Subject: Chamber Construction Manual
Posted by [Clemens Adler](#) on Thu, 25 Mar 2004 08:24:30 GMT
[View Forum Message](#) <> [Reply to Message](#)

I updated the chamber construction manual (to version 1.1).

1) [image001.gif](#), downloaded 2372 times

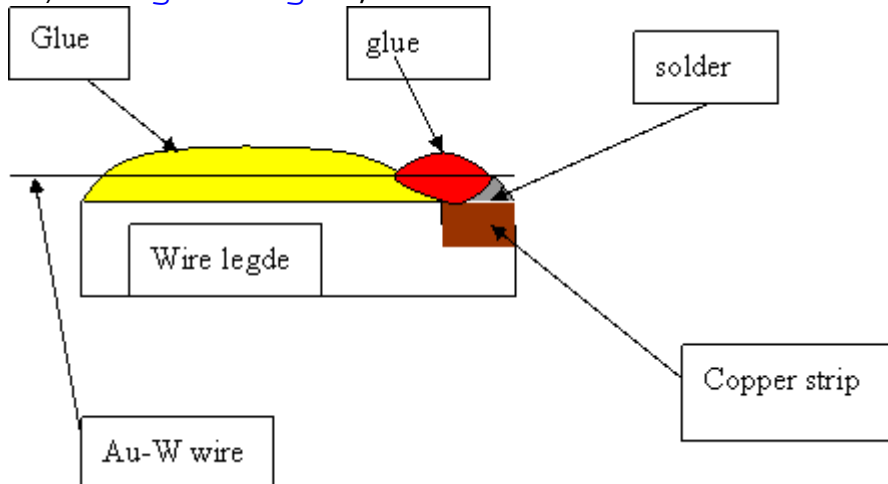
2. An suggestion: Oleg suggests to put some glue to between the glue which holds the anode wire on the wire ledge and the copper strip where the wire is soldered (see attached picture by Oleg).

"after soldering of anode wires we put glue (red color) to fix the wire, solder and copper

strip together. It is need to remember that we have to safe a clean place on the copper strip to solder HV cable."

We also had this idea and did it on some chambers, but after discussion with Joerg at GSI, who never had any similar problem we thought that probably sanding the wire ledge edges is good enough and will solve the problem.

So I would like to hear from GSI (Joerg) and Bukarest (Mihai) what they think. Since we have not put anodes on a chamber since a while due to technical difficulties with machiniery in our lab, I cannot tell at this moment what our experiences with sanding the wire ledges are. I will, therefore, not add this into the construction manual, until there are some more opinions about this additional step.
